UNITED STATES
NUCLEAR REGULATORY COMMISSION
WASHINGTON, D. C. 20555

AMENDMENT TO FACILITY OPERATING LICENSE

Amendment No. 102
License No. DPR-35

SAFETY EVALUATION BY THE OFFICE OF NUCLEAR REACTOR REGULATION
RELATING TO STANDBY LIQUID CONTROL SYSTEM
BOSTON EDISON COMPANY
PILGRIM NUCLEAR POWER STATION
DOCKET NO. 50-293

Figure 3.4 - 1
 Sodium Pentaborate Solution
 Volume and Concentration Requirements

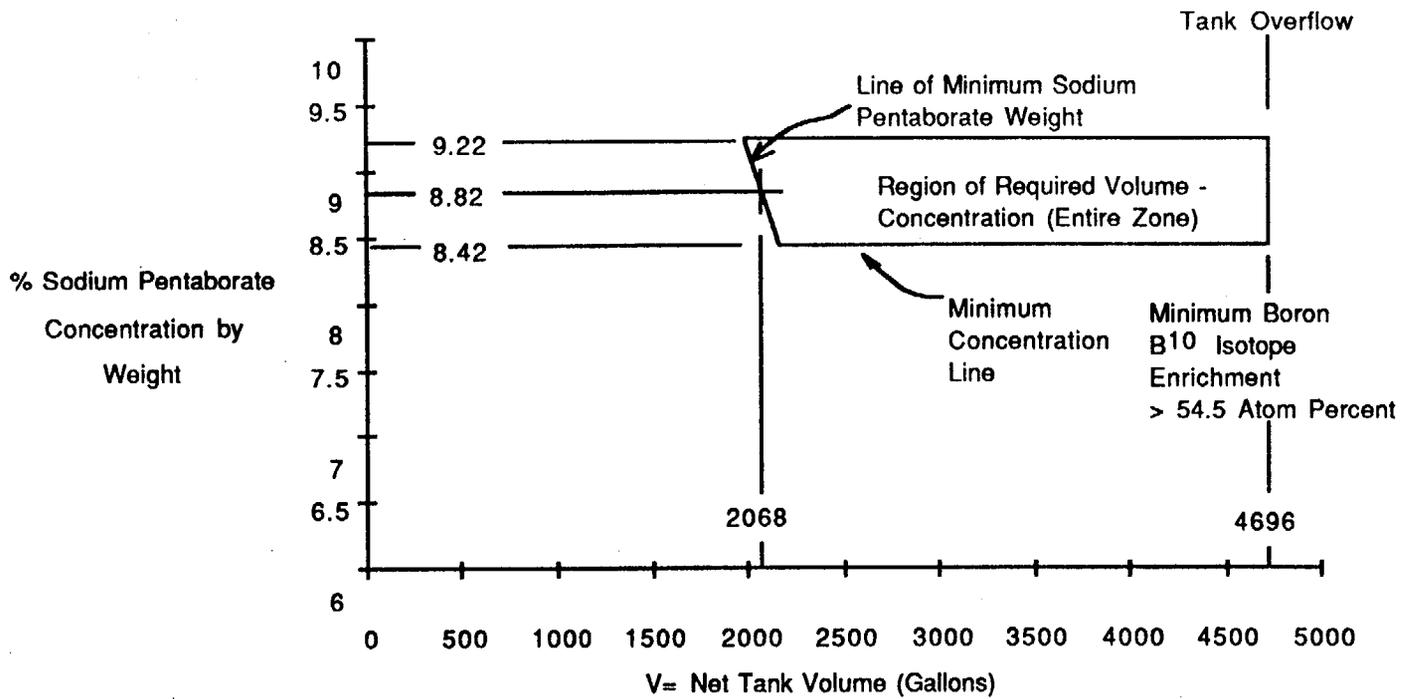
1. The net volume - concentration of the Liquid Control Solution in the liquid control tank shall be maintained as required in Figure 3.4-1.
2. The temperature of the liquid control solution shall be maintained above 48°F. If the solution temperature falls to or below 48°F, the system will be flow tested to verify aflow path.
3. The enrichment of the liquid control solution shall be maintained at a B¹⁰ isotope enrichment exceeding 54.5 atom percent.

Because the concentration/volume curve has been revised to reflect the increased B¹⁰ isotopic enrichment, an additional requirement has been added to evaluate the solution's capability to meet the original design shutdown criteria whenever the B¹⁰ enrichment requirement is not met.

507,850 pounds (227 inch vessel). The new limits are reflected in the revised T/S section 3.4.C.3 and Figure 3.4.1.

The temperature/concentration requirements of existing Figure 3.4.2 are no longer required because the curve extends down only to 9.4% sodium pentaborate concentration and is based upon naturally enriched sodium pentaborate. The proposed revised concentration limits, in proposed TS Figure 3.4-1 allow a maximum concentration of 9.22% enriched sodium pentaborate. At 9.22% enriched sodium pentaborate concentration, the temperature required to preclude sodium pentaborate precipitation (with a 10°F margin) is 48°F. The controlled building temperatures provide assurance that it will be difficult for the SLCS solution to approach this limit, and system alarms provide operator notification of such a potential event. Because of the 10°F margin to potential sodium pentaborate precipitation at monitored concentration levels, the 48°F temperature limit provides equivalent protection to that considered in the original safety evaluation. The 48°F temperature limit, which is included in the proposed TS, preempts the previous temperature - concentration curve provided in Figure 3.4.2. Accordingly, the staff finds the proposed TS Section 3.4.C.2 and deletion of Figure 3.4.2 to be acceptable.
